## Design Review Subcommittee (DRSC)

**SUBJECT:** **Site Plan Permit 19-203, Architectural Permit 19-204, and Conditional Use Permit 19-205, Plaza by the Sea Drive-Thru, 610 Camino De Los Mares,** a request to demolish a freestanding commercial building and construct a new commercial drive-through building for two tenants in an existing commercial center at 610 - 628 Camino De Los Mares within a city Gateway and the Community Commercial 4 Zone (CC4). A dividing wall between Plaza by the Sea and neighboring Ocean View Plaza (638 Camino De Los Mares) is proposed to be removed to allow for shared access between the retail centers.

**SHEET NUMBER**  
**SP.1**

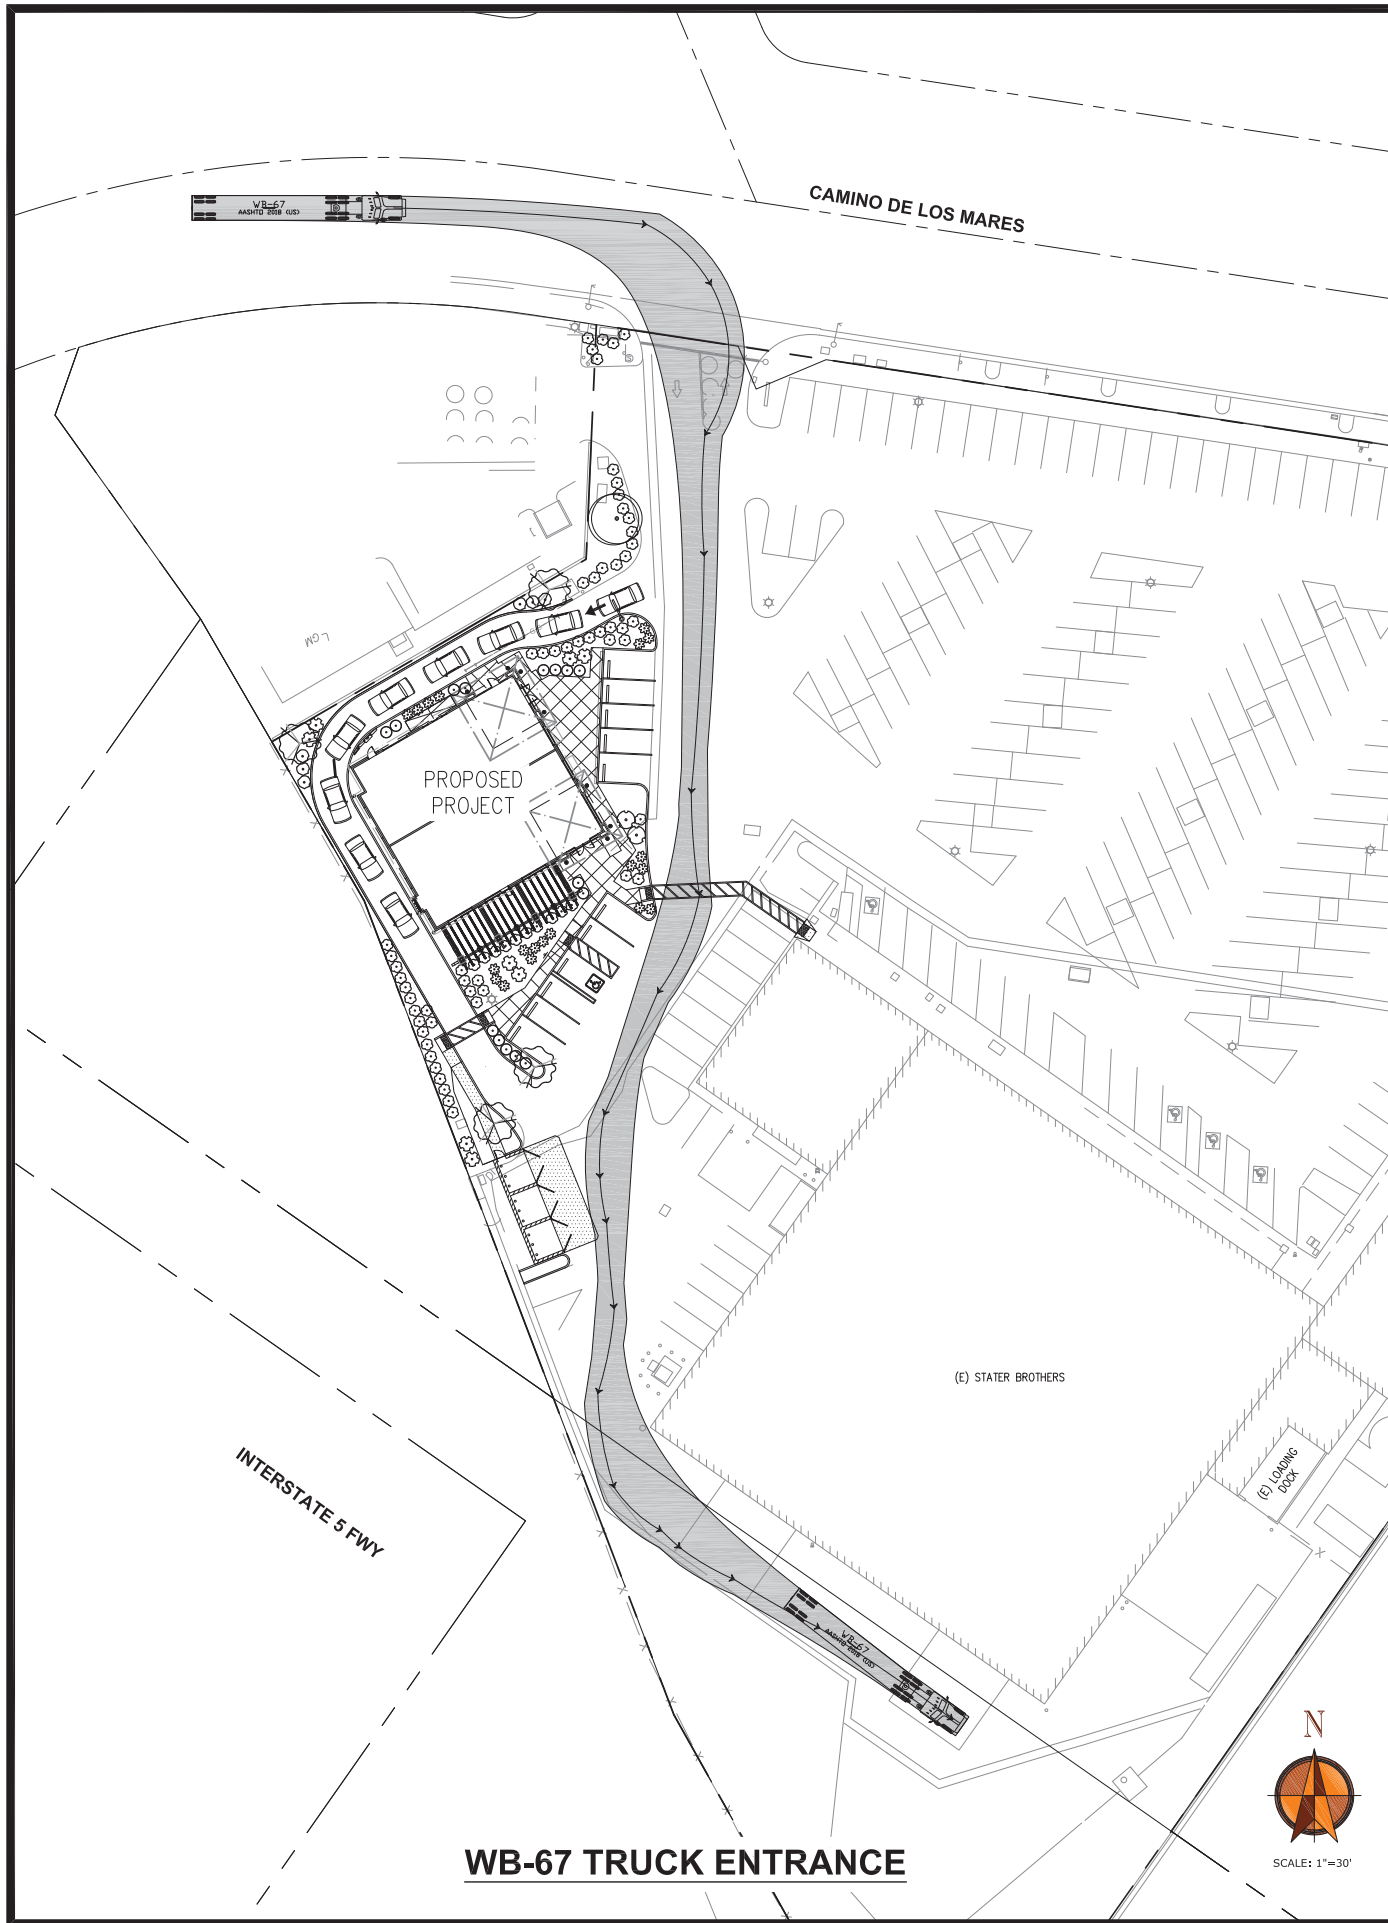
6. Incorporate additional pedestrian features where possible, such as bike racks and benches. Special attention should be added between buildings C and D where the wall between Ocean View and Plaza by the Sea is proposed to be removed. This space should feel like a “paseo” more than a street.

8. Designate a reserved parking stall for “drive through delivery” as one remedy to the site constraints of a limited queue length.
9. Provide a couple of additional trees on the south side of the proposed new building near the patio area.

**LS.1**

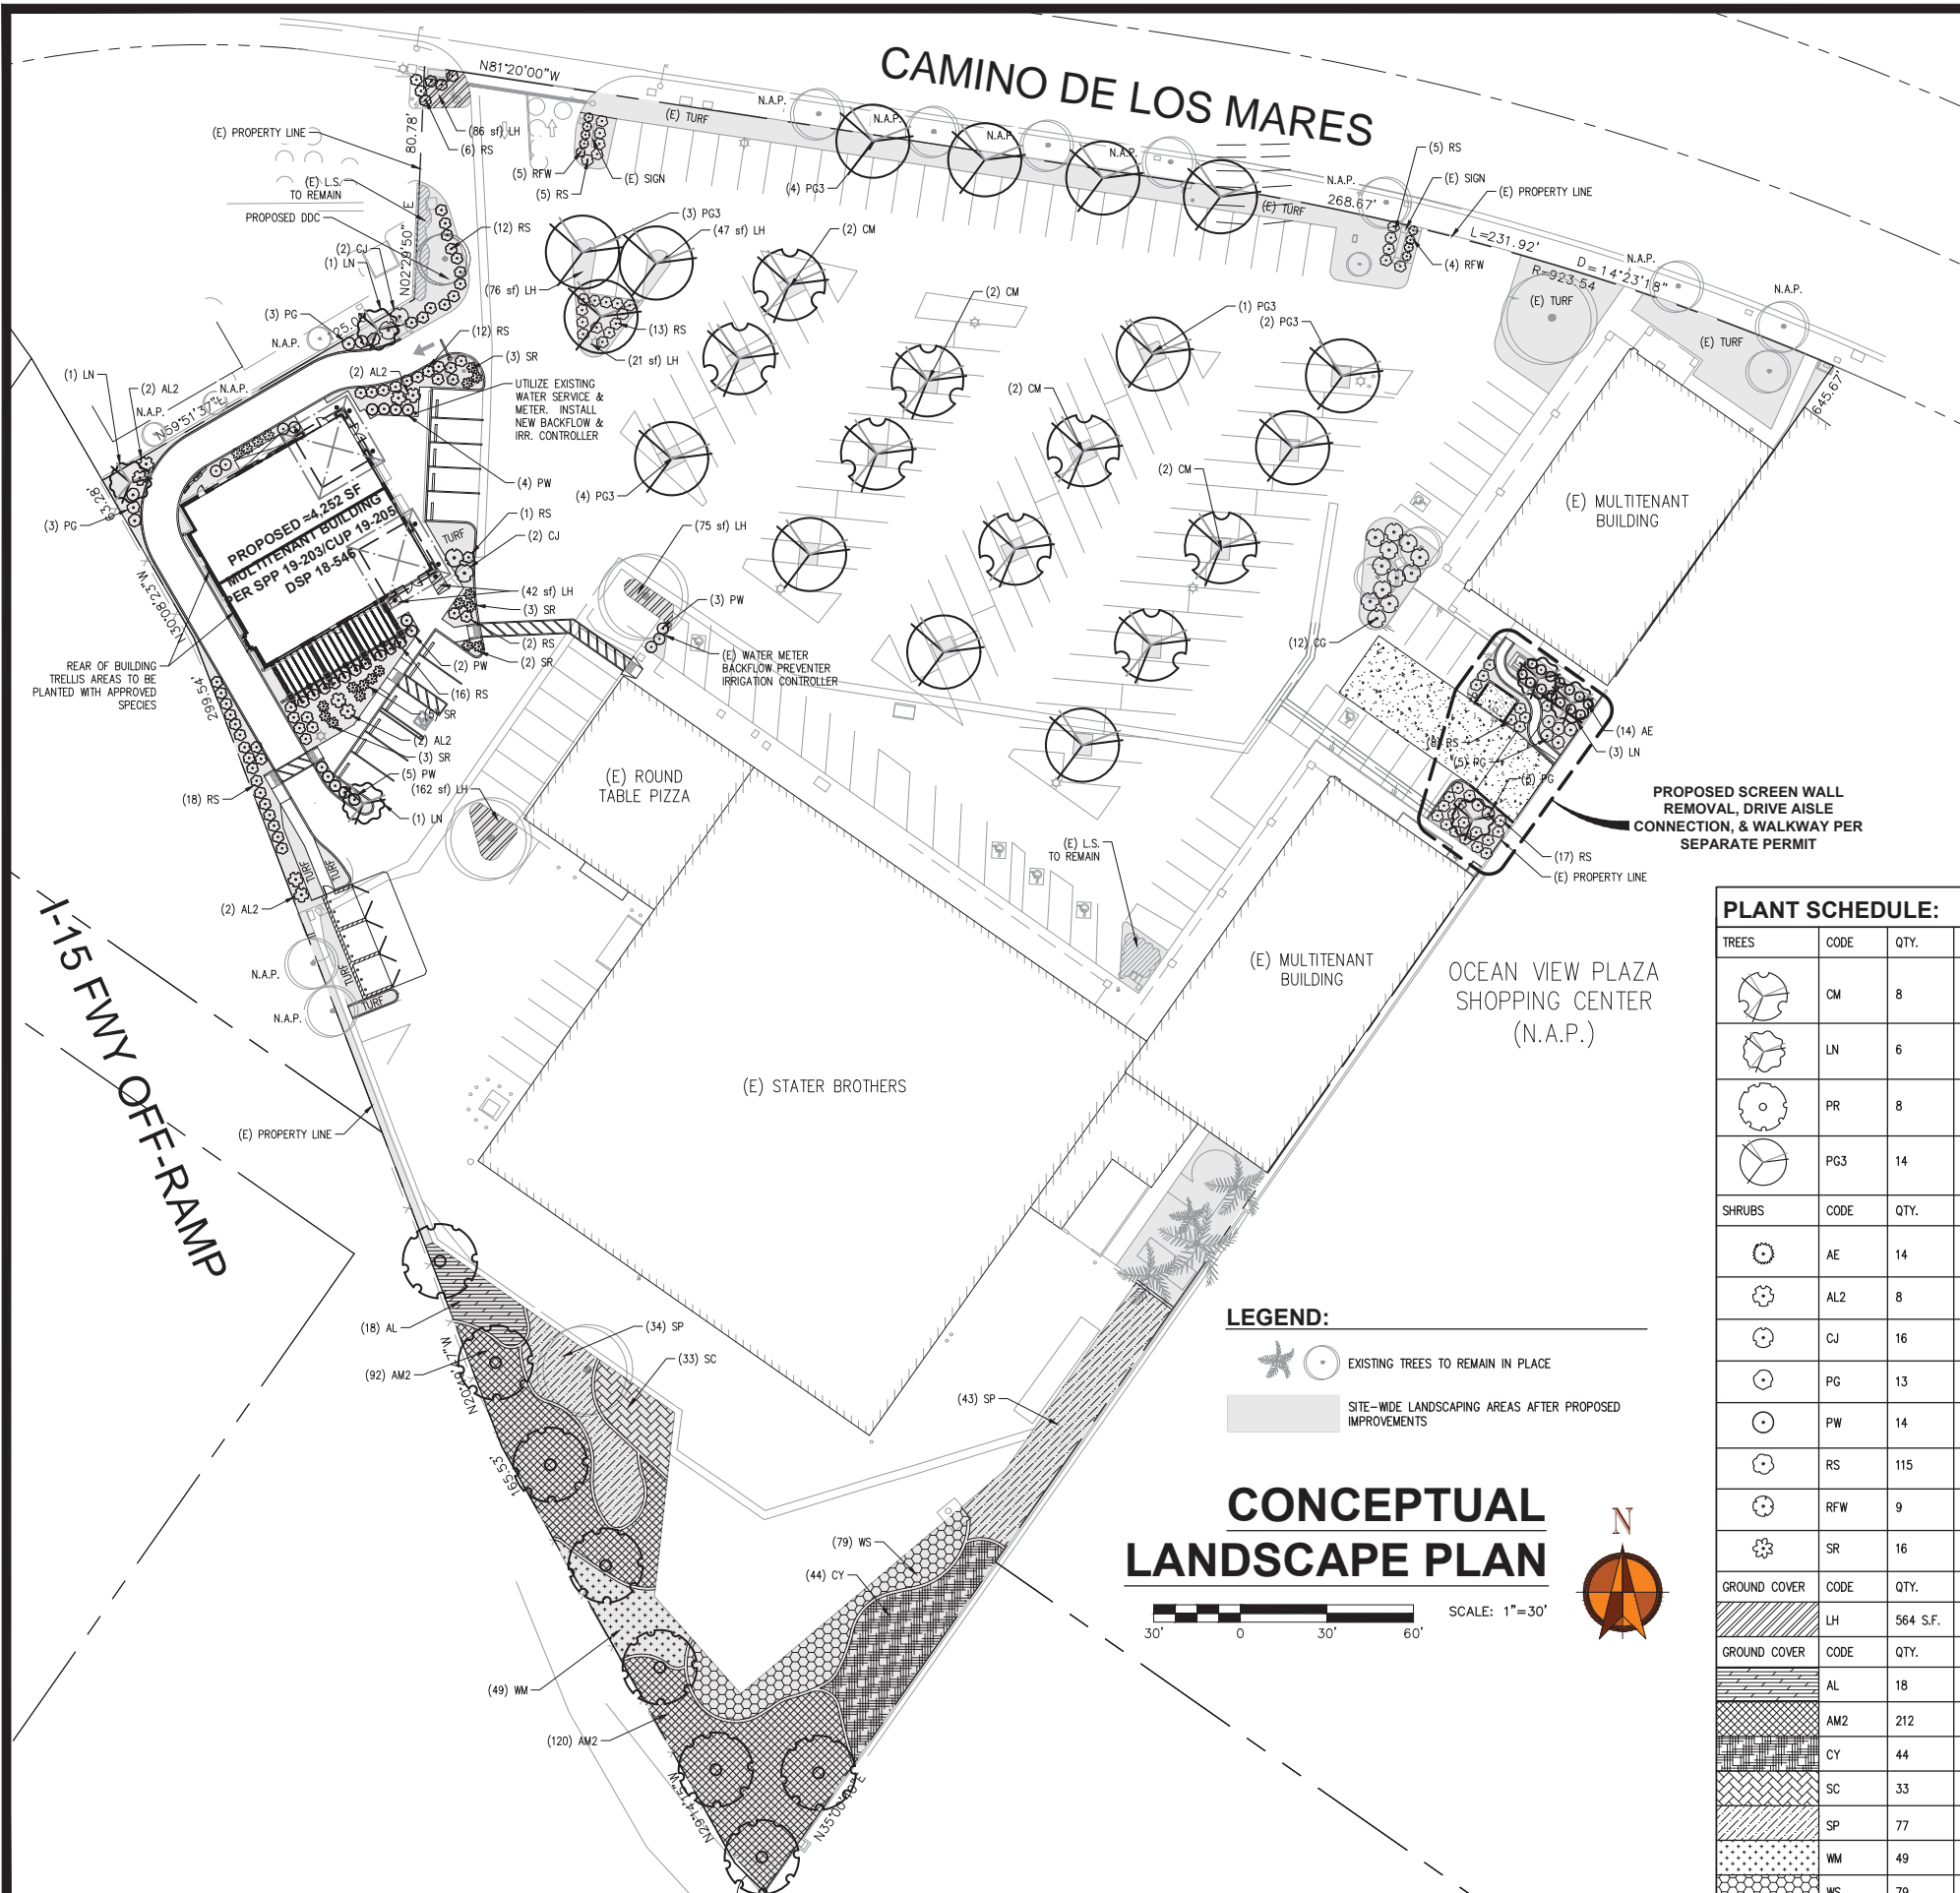
Within the site, 29 trees are proposed to be removed; 36 trees are proposed to be planted. The majority of removal and replanting occurs in the parking lot area. Planning noted on a site visit that the existing crepe myrtle trees in the parking lot were failing to thrive. The crepe myrtle trees are proposed to be replaced by a blend of carrotwood and Natchez crape trees. The landscaping around the proposed building would also change. Existing

trees (including a date palm, sycamore, and several eucalyptus) would be removed, and three new Natchez crape trees would be planted. Staff notes there is room for several additional trees in this area, including planter along the ADA pathway and adjacent to the patio. Finally, turf is proposed to be replaced in the area of the wall removal and replaced with shrubs and three Natchez crape trees.

**PROPOSED TRASH ENCLOSURE - PLAN & ELEVATIONS**

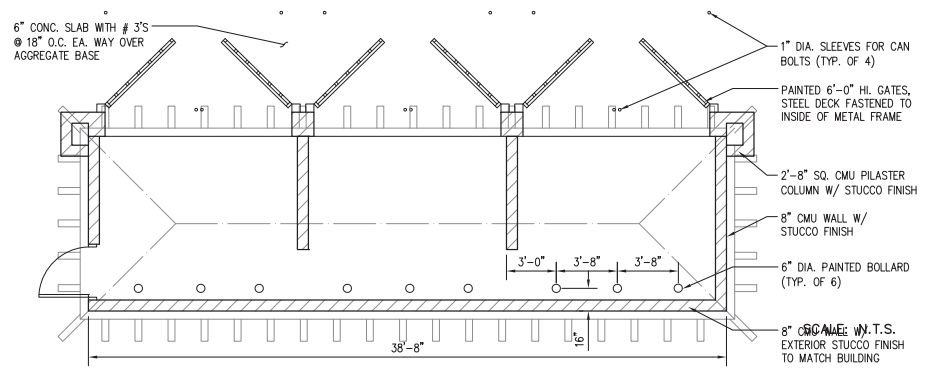
7. Between buildings C and D, push the trash enclosure back from the connecting “paseo” towards the sidewalk to allow for better visibility for cars parking and backing out of adjacent stalls. Provide an updated elevation showing the materials of the trash enclosure; it should mimic the style of the new enclosure by the outparcel building.

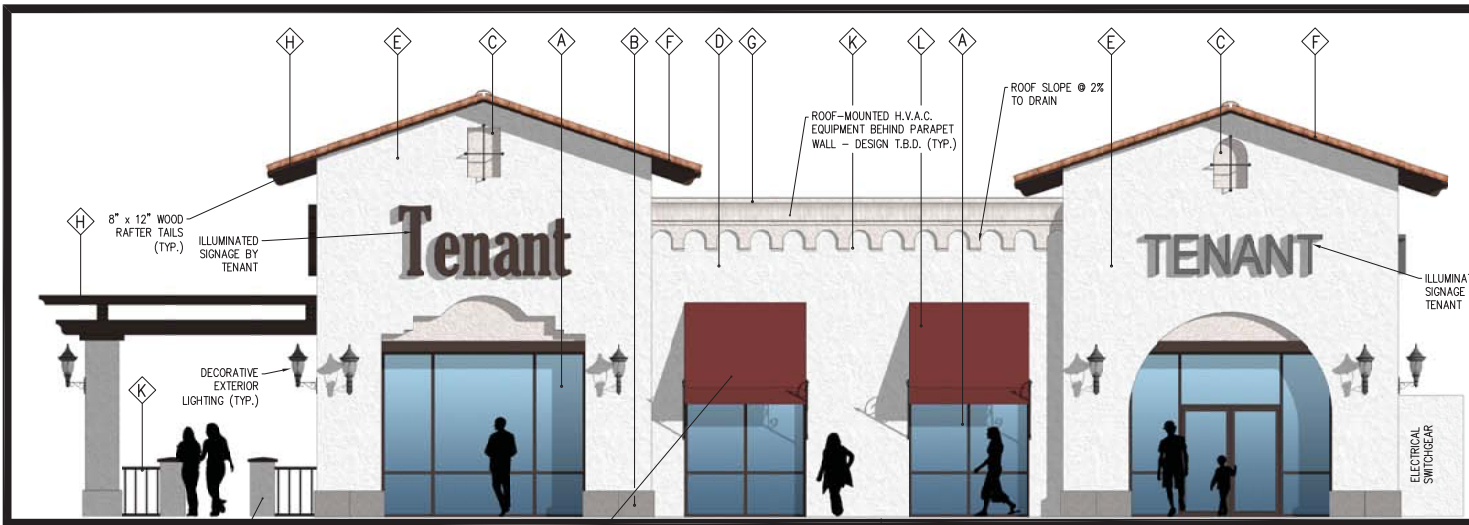
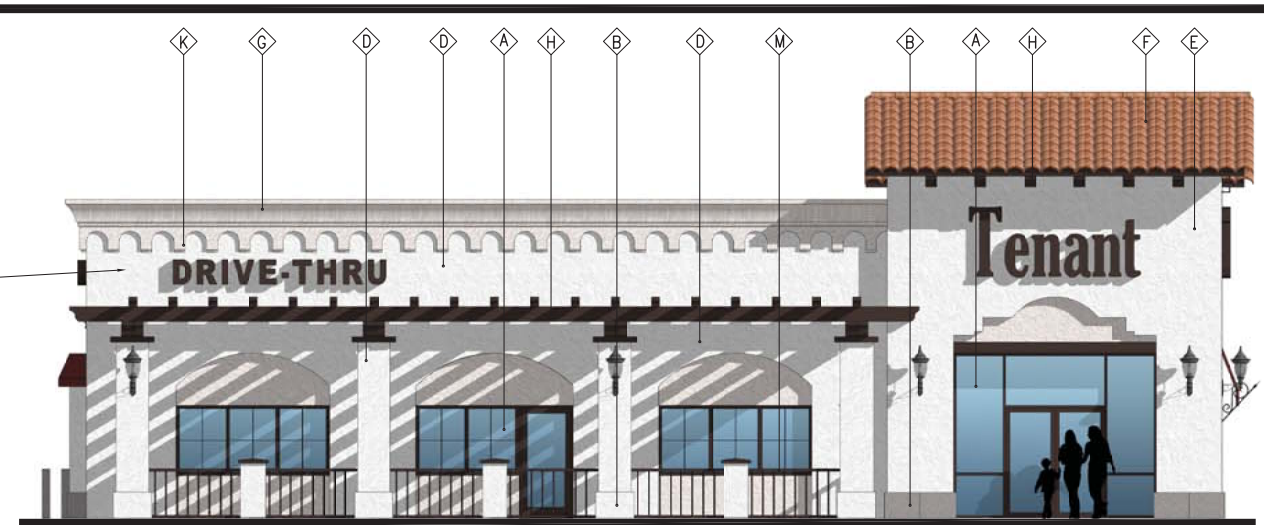
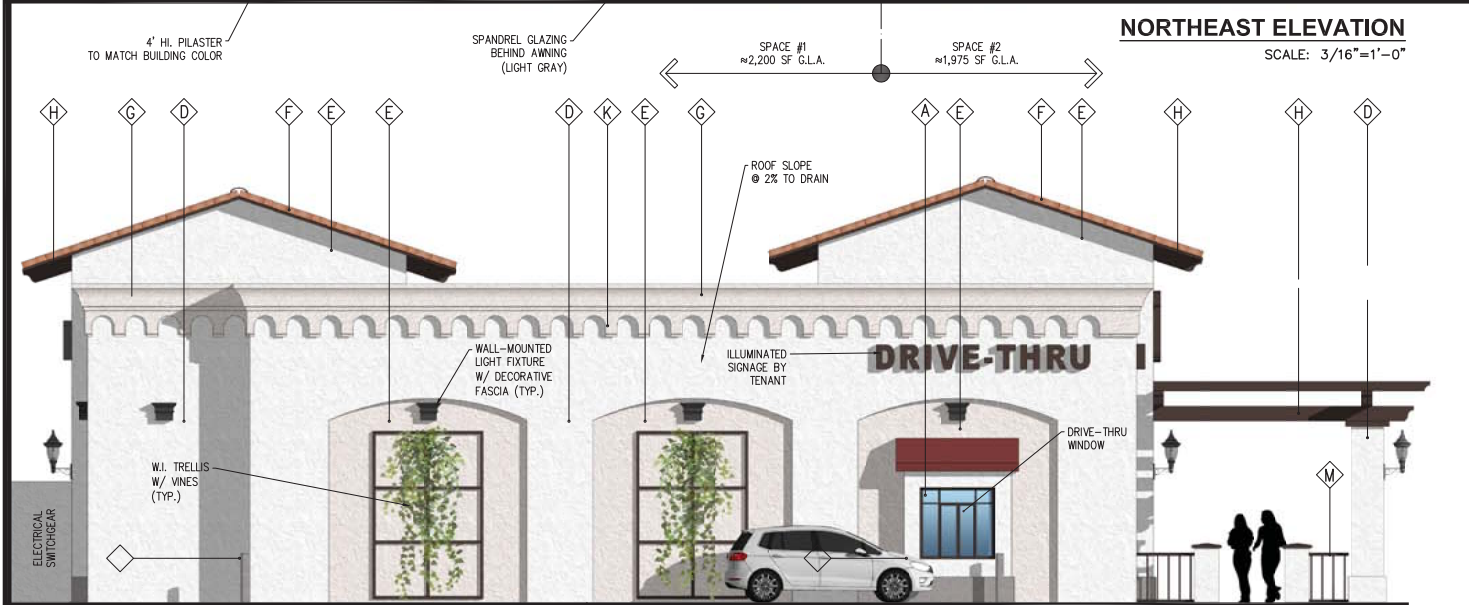
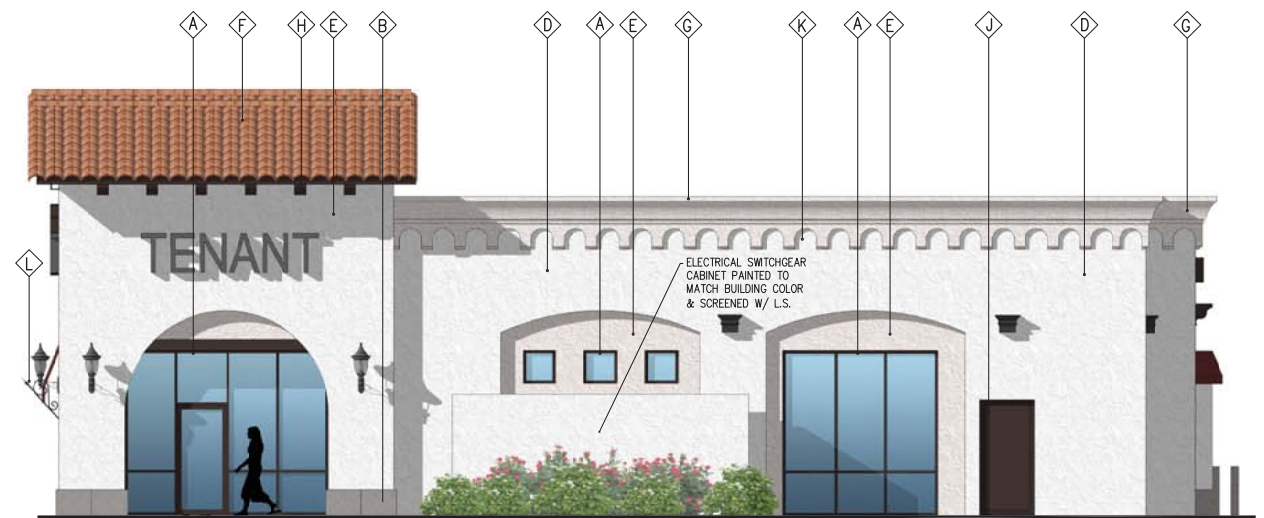
1. The stucco insets by the entries should have the same inset depth as the doorway (minimum 12"). It is strongly preferred to accent the doors with a tile surround as opposed to filling the opening with glass. For the arched opening, use an arched glass storefront system to match the opening as seen in Figure 5.

2. Insets should be functional. Use a rectangular insets for rectangular windows (such as in the patio area) and arched insets for arched doorway patterns.
3. Indicate awnings with a "sweep" instead of a rigid design. Use colors from the Santa Barbara color sample palette.
4. Provide sample exterior detail elements within the plan set, to include light fixtures, tile, etc. With new construction (as opposed to remodels of existing buildings), details should be less "modern" and more authentically Spanish Colonial in styling.

5. Reuse the decorative tiled inset design from the primary entry (seen in Figures 2 and 3) around the drive through window to accent this space. Remove the two other minor

insets (segmented arches) on the southwest elevation, but maintain the vine trellises -- substituting for a more decorative shape or design that is interesting with or without plant material, such as this:

10. Amend the Discretionary Sign Permit (if needed) to address any new signage on the building. Remove any signage from the rear elevation as this is freeway visible. This will be incorporated as a condition of approval. (The existing DSP prescribes sign size, material, mounting, and illumination.)
